RIVER BEND

ATTACHMENT 2: ITS - PSTS COMPARISON DOCUMENT

ATTACHMENT 2A

MARKUP OF ITS

CORE FLOW (% RATED)
FIGURE 3.4.1.1-1
THERMAL POWER VERSUS CORE FLOW

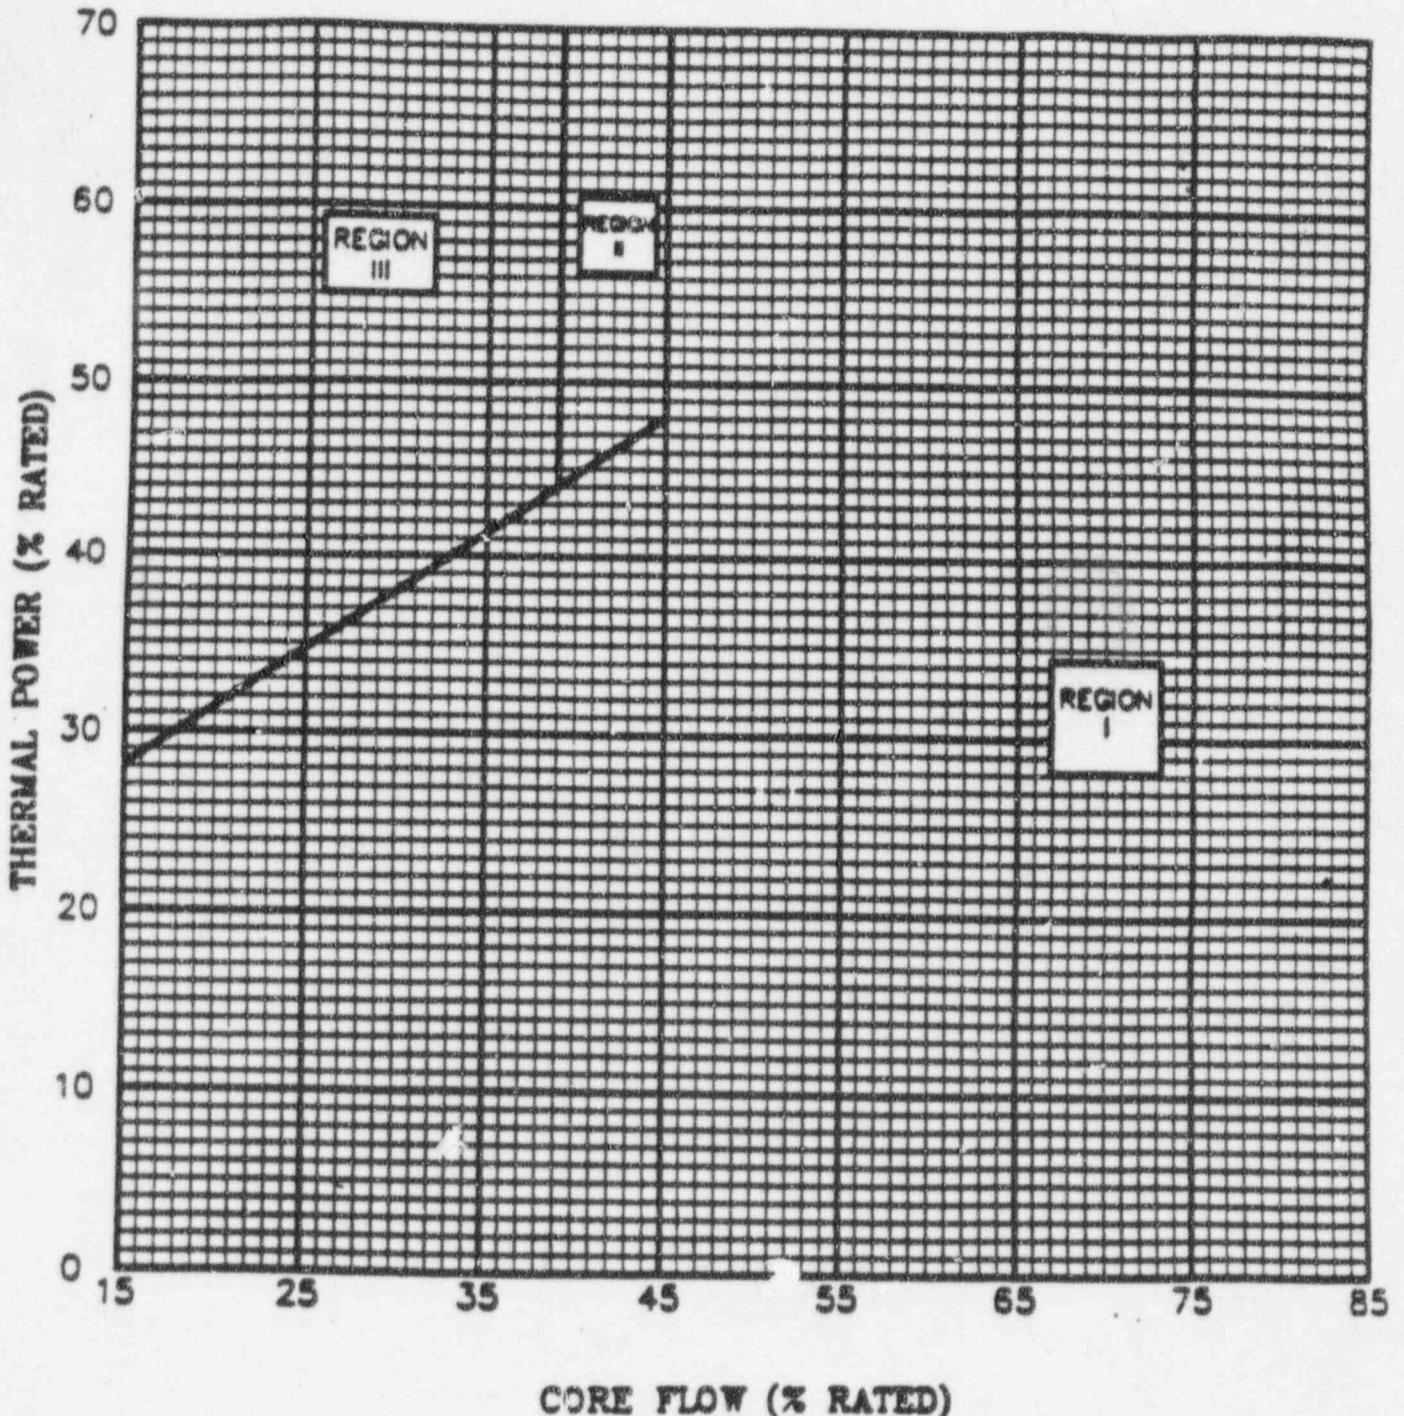
3.4 #17 LC03.4.1 COND C/D With one or two reactor coolant system recirculation loops in operation and total core flow greater than 39% and less than 45% of rated core flow and THERMAL POWER greater than the limit specified in Region II of Figure 3.4.1.1-1: (LA1)

h. LC03.4.1 COND E With one or two reactor coolant system recirculation loops in operation and total core flow less than 39% of rated core flow and THERMAL POWER greater than the limit specified in Region III of figure 3.4.1.1-1, immediately within 15 minutes initiate corrective action to increase core flow to greater than or equal to 39% of rated core flow or reduce THERMAL POWER to less than the limit specified in Region III of Figure 3.4.1.1-1 within 4 hours. (LA1)

3.4.11-1
 FIGURE 3.4.6.1-1
 MINIMUM TEMPERATURE REQUIRED VS REACTOR PRESSURE
 RCS

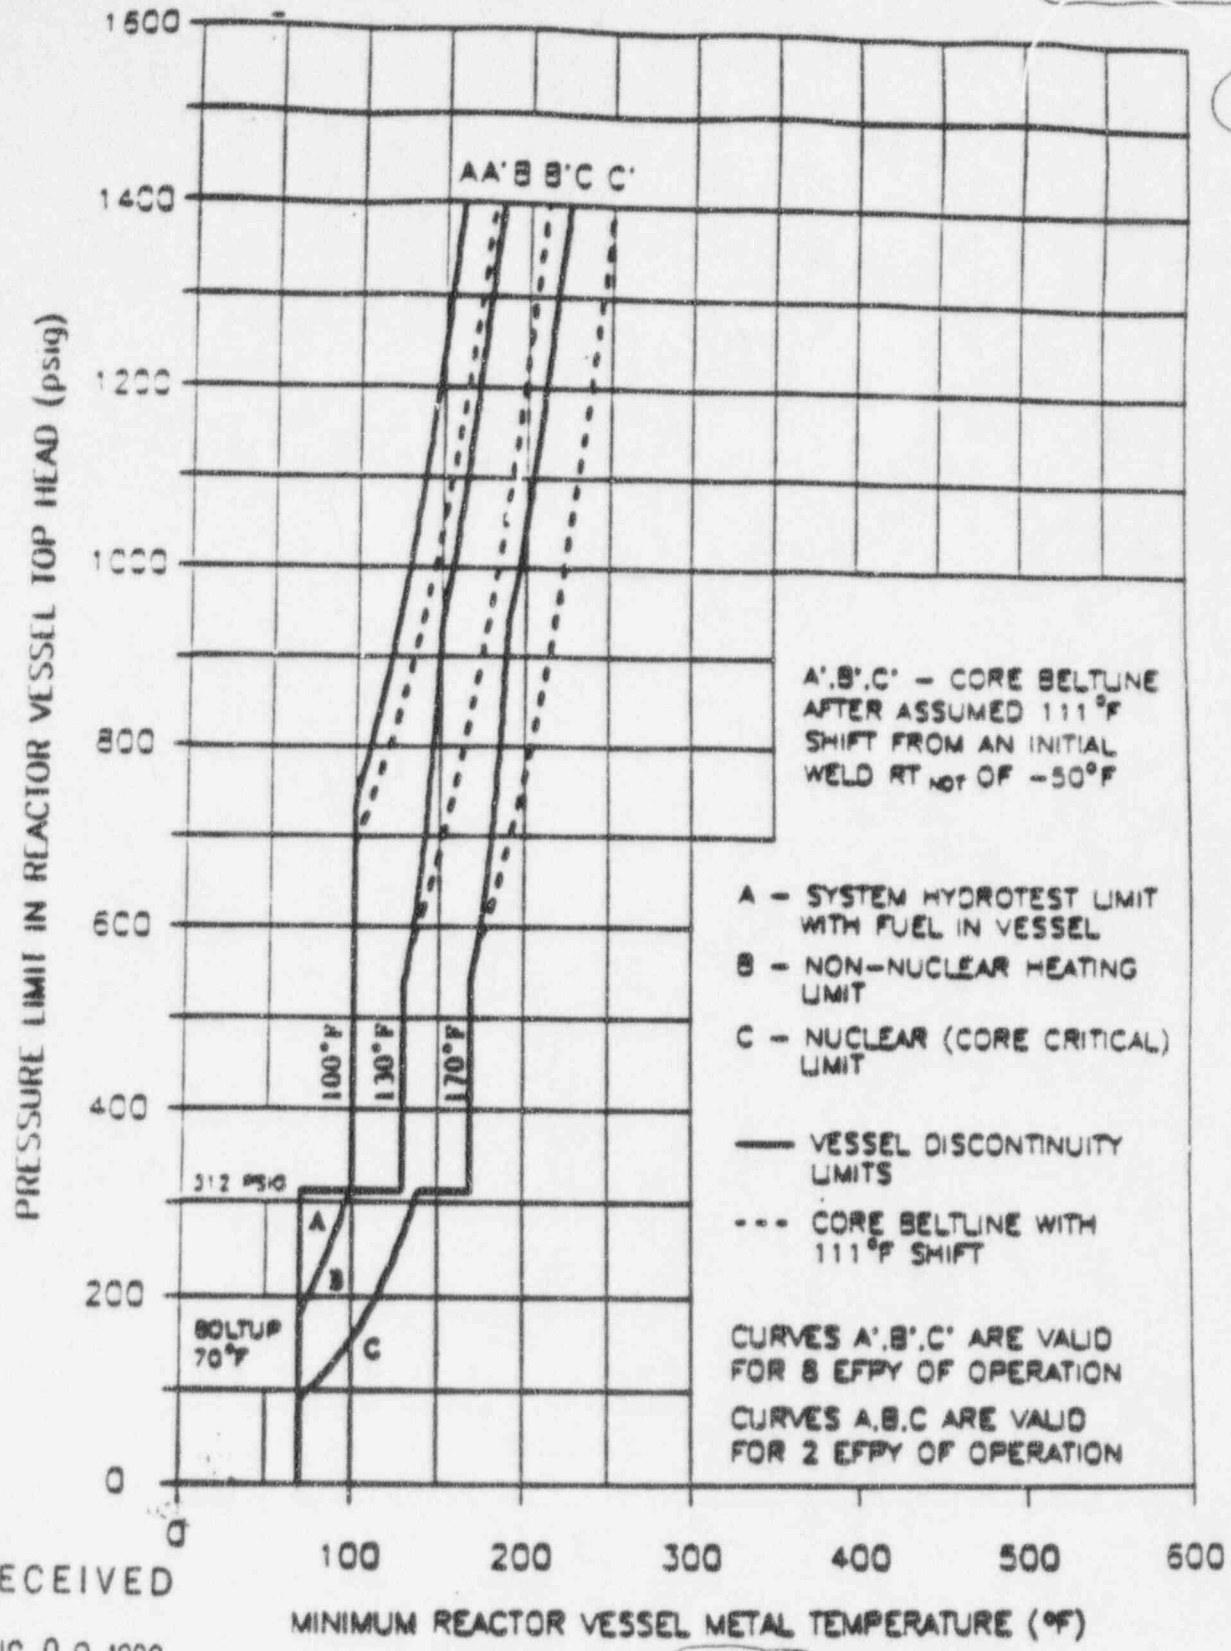
A5 INSERT SR 3.4.11.6 NOTE
SR 3.4.11.7 NOTE

3.4
#72

Bases Figure 3.4.1-1 (page 1 of 1)
Thermal Power/Core Flow Stability Regions

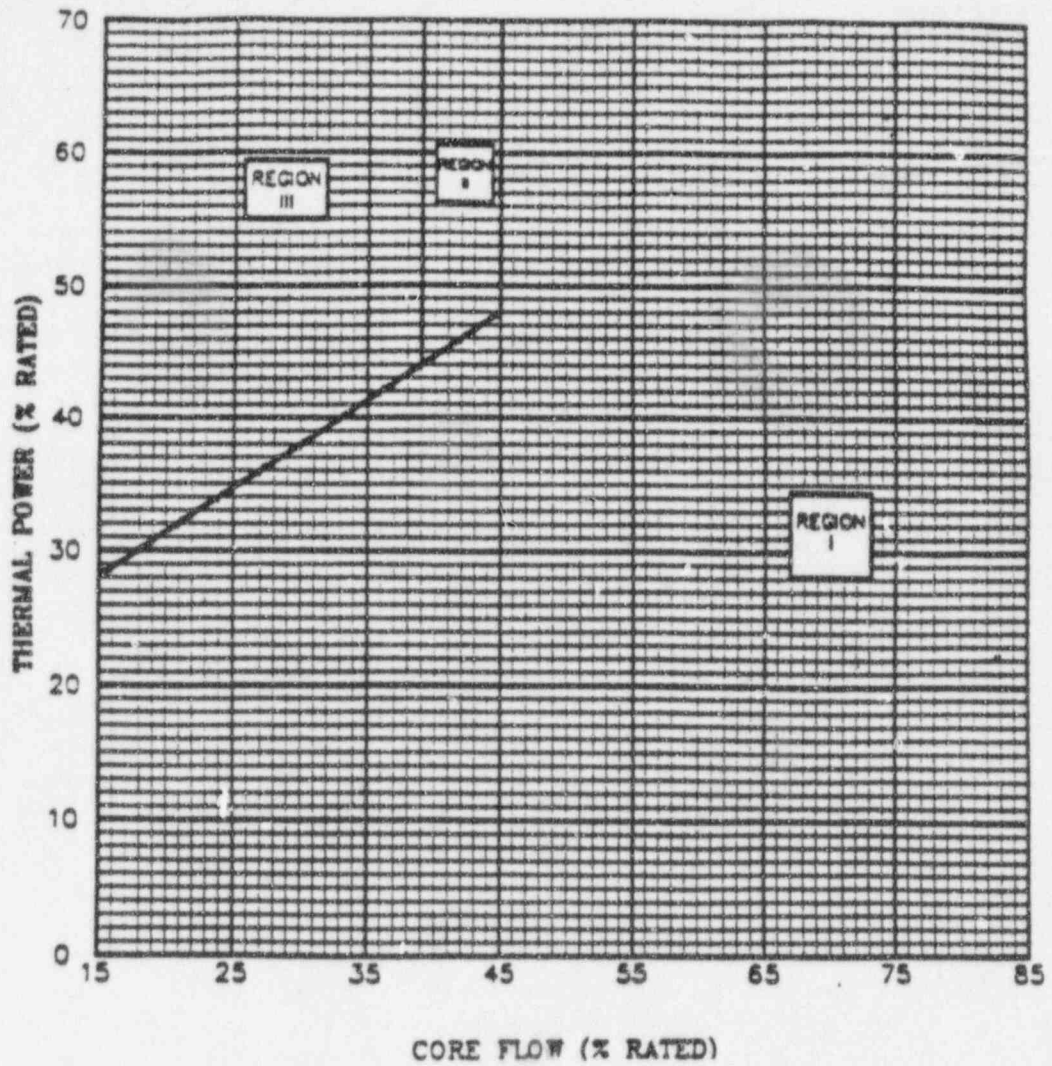
3.4
#17

- a. Total core flow $\geq 45\%$ rated core flow; or
- b. THERMAL power and total core flow within Region I of Figure 3.1.1-1.

FIGURE 3.4.11-1 (Page 1 of 1)

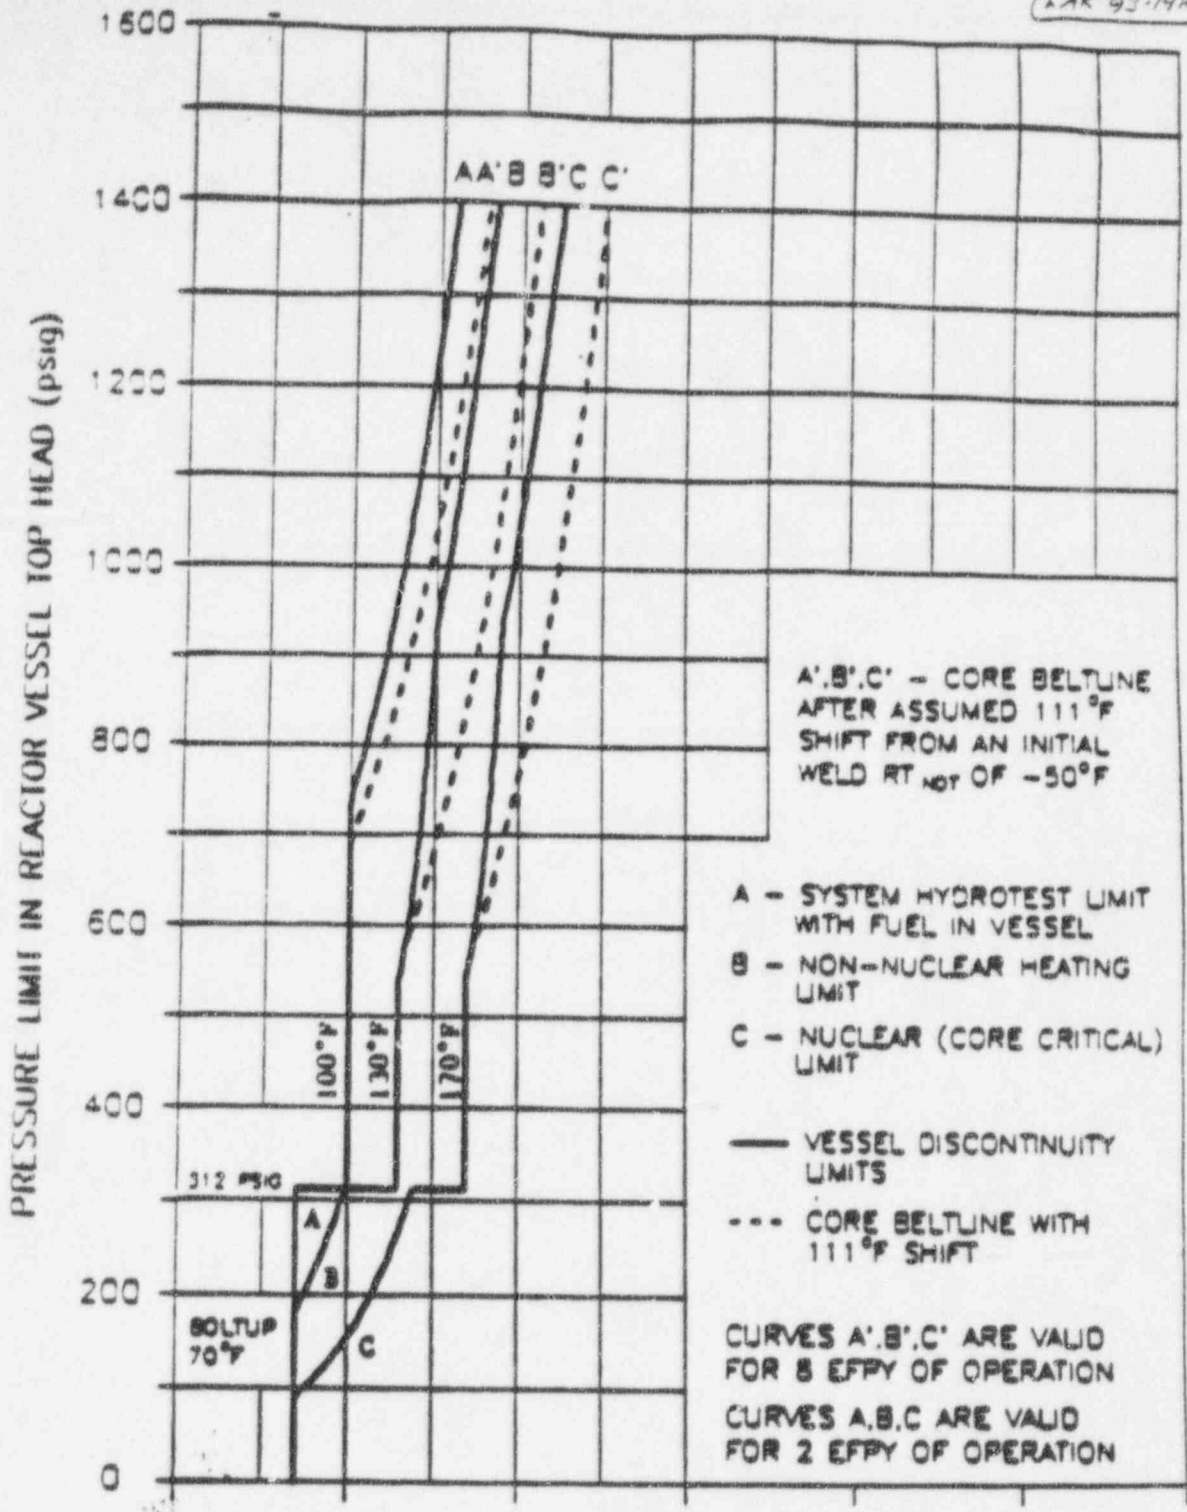
3.4 #72

INSERT
FIGURE 3.4.11-1

4.1-1
FIGURE 4.1-1

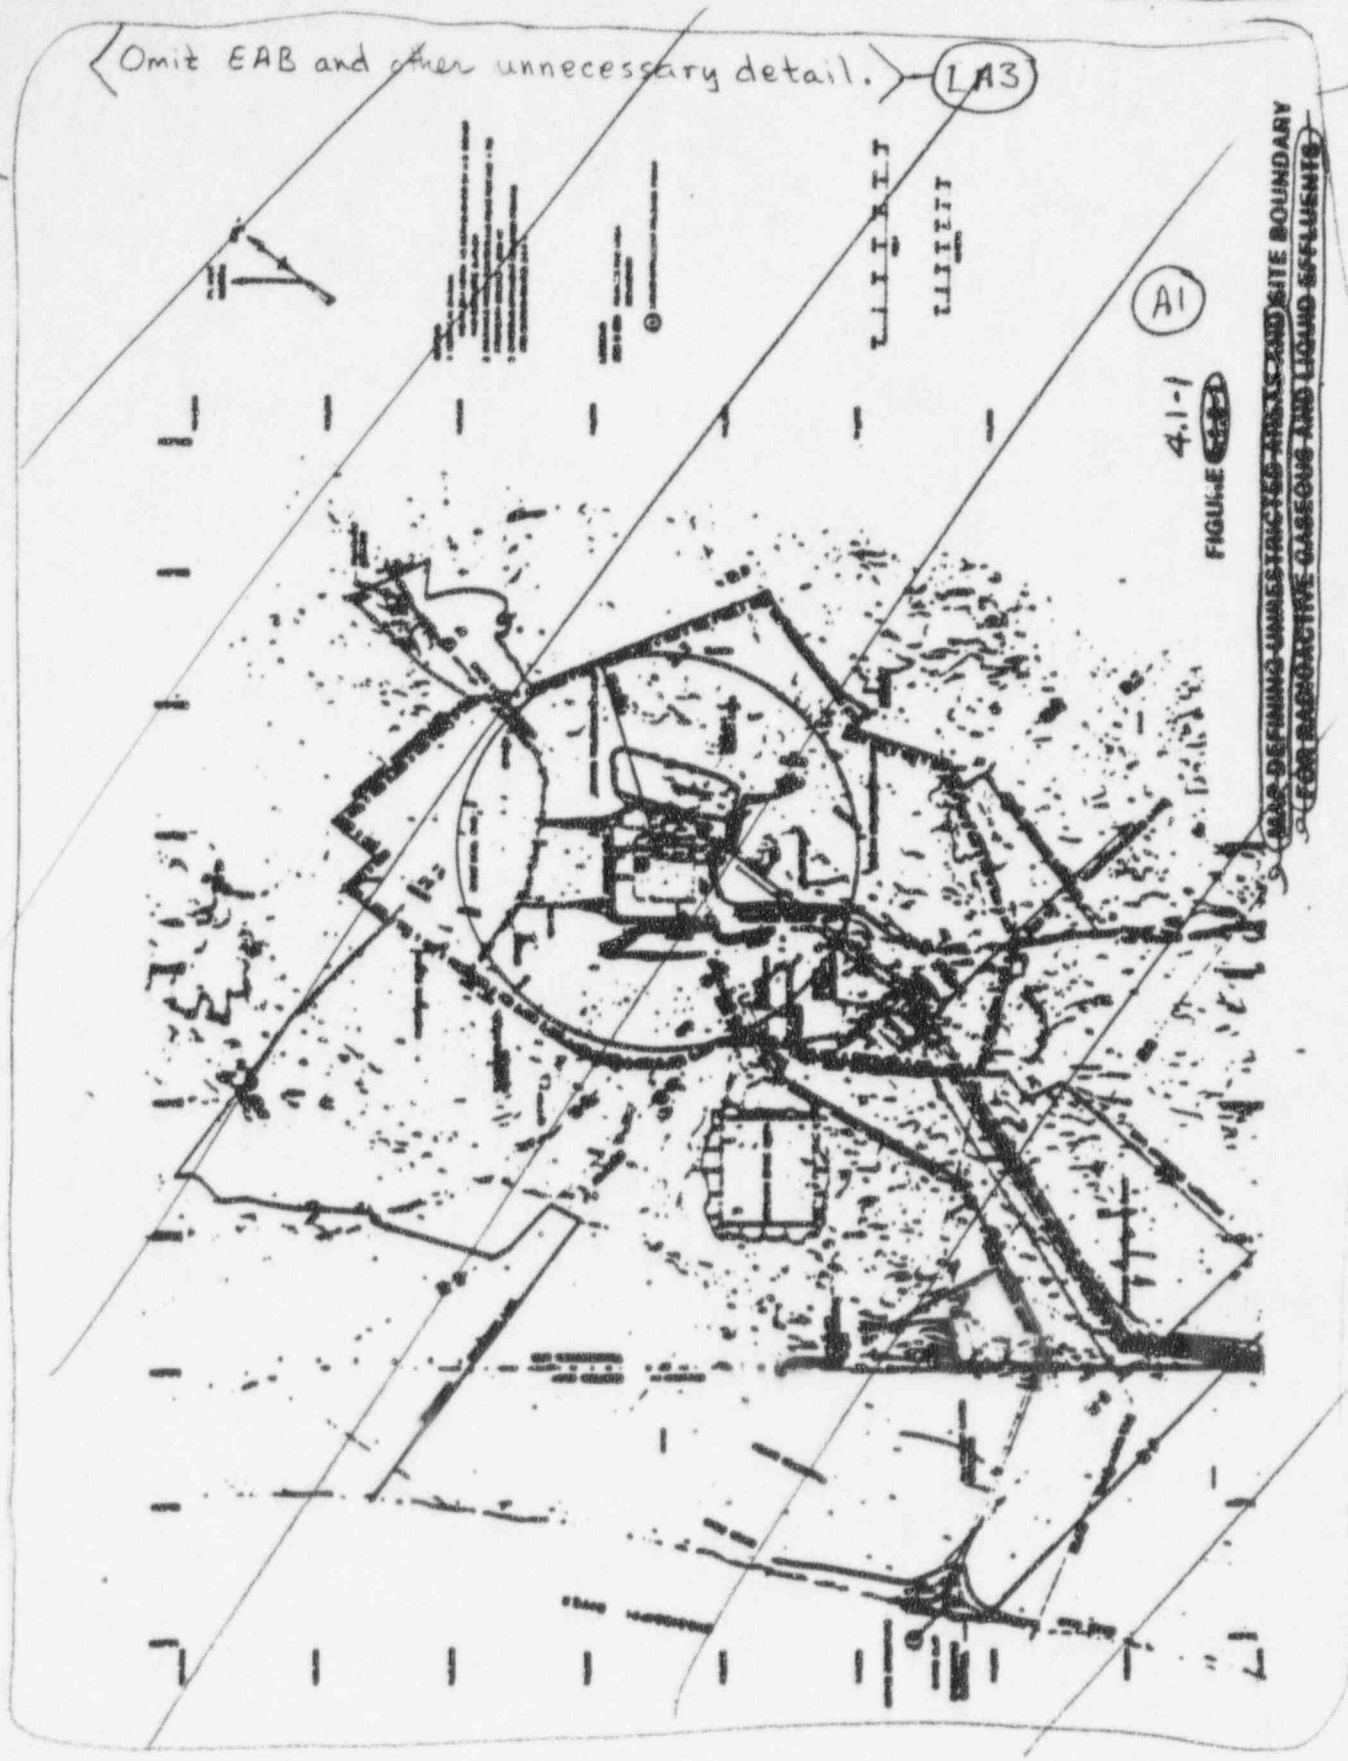
Omit EAB and other unnecessary detail. LA3

The site and exclusion area boundaries shall be as described or as shown in Figure 4.1-1. The area boundary include the area shall have a radius of 3000 ft from the centerline of the reactor.
